Access Compliance Report

Public Rights-of-Way

(Curb Ramps)

Intersection ID: 10025869	Main Street: ELEVATION_POINT_DR	Cross Street: N/A	Location:	N
ADA ID: D15F936A6B76	Ramp Type: Perp	Initial Pass/Fail: Pass	Overall Compliance: No	Severity Score: 0.25
Codes/Mitigation Info/Possible Solution		Field Measurements/Component Compliance

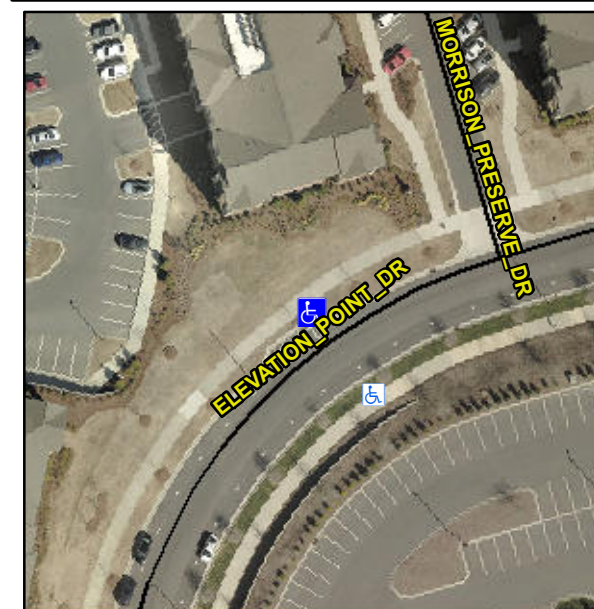
Not Found, R304.5.3, R304.2.2-Perp, R304.3.2-Para

Compliance	Description	Data	Compliance	Description	Data
N/A	Ramp Length (in)	42.0	Yes	Ramp Slope (%)	5.2
Yes	Ramp Width (in)	58.0	No	Ramp XSlope (%)	4.2
Yes	Flare Type L	Curbed_NoWalkSurface	Yes	Flare Type RT	N/A
Yes	Flare Slope LT (%)	N/A	N/A	Flare Slope RT (%)	N/A
N/A	Flare Traversable LT?	No	N/A	Flare Traversable RT?	No
Yes	Landing Length (in)	100.0	Yes	DWS Provided?	Yes
Yes	Landing Width (in)	69.5	Yes	DWS Contrast?	Yes
No	Landing Slope (%)	2.3	Yes	DWS Length (in)	24.0
Yes	Landing X Slope (%)	1.6	Yes	DWS Full Width?	Yes
N/A	Landing Curb? (Y/N)	Yes	Yes	DWS Offset (in)	0.0
N/A	Shared Landing?	No			
Yes	Gutter Ponding?	No	Yes	Gutter Slope (%)	1.7
Yes	Gutter Lip Ht (in)	0.0	Yes	Gutter X Slope (%)	1.3
N/A	Painted X Walk1?	No	N/A	Painted X Walk2?	N/A
	X Walk 1 Direction	To SE		X Walk 2 Direction	N/A
N/A	X Walk 1 Width (in)	N/A	N/A	X Walk 2 Width (in)	N/A
	X Walk 1 Slope (%)	1.2		X Walk 2 Slope (%)	N/A
	X Walk 1 X Slope (%)	1.7		X Walk 2 X Slope (%)	N/A

Remove & Replace Entire Ramp.
